COMPLIANCE AUDIT PROGRAM

# **GLENELLA QUARRY**

Title: Compliance Audit Program: Glenella Quarry, Glenella Quarry Pty Ltd

As part of the compliance audit program, an audit of the Glenella Quarry was undertaken on 13 February 2019.

Figure 12 New exit road on eastern side of operation (facing south)

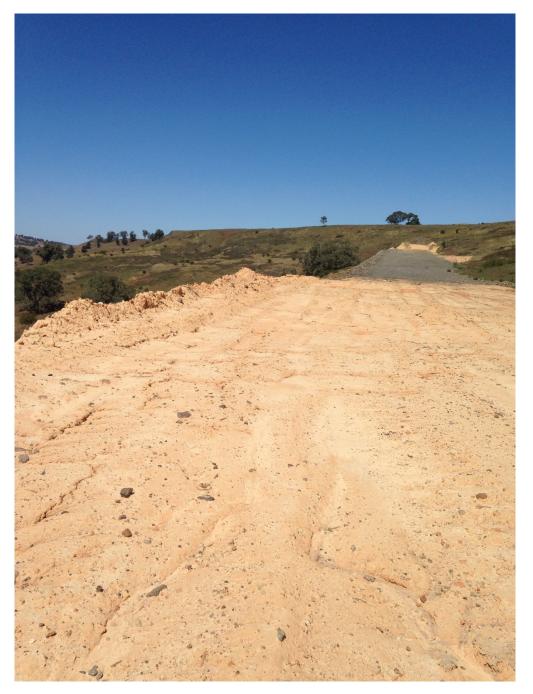
- Site operations overview and active quarry pit (refer to figure 1 and 2)
- Water management (refer to figure 3 and 4)
- Product management (refer to figure 5)
- Environmental management issue examples (refer to figure 6, 7 and 8)
- Rehabilitation (refer to figure 9, 10 and 11)
- New infrastructure (refer to figure 12)
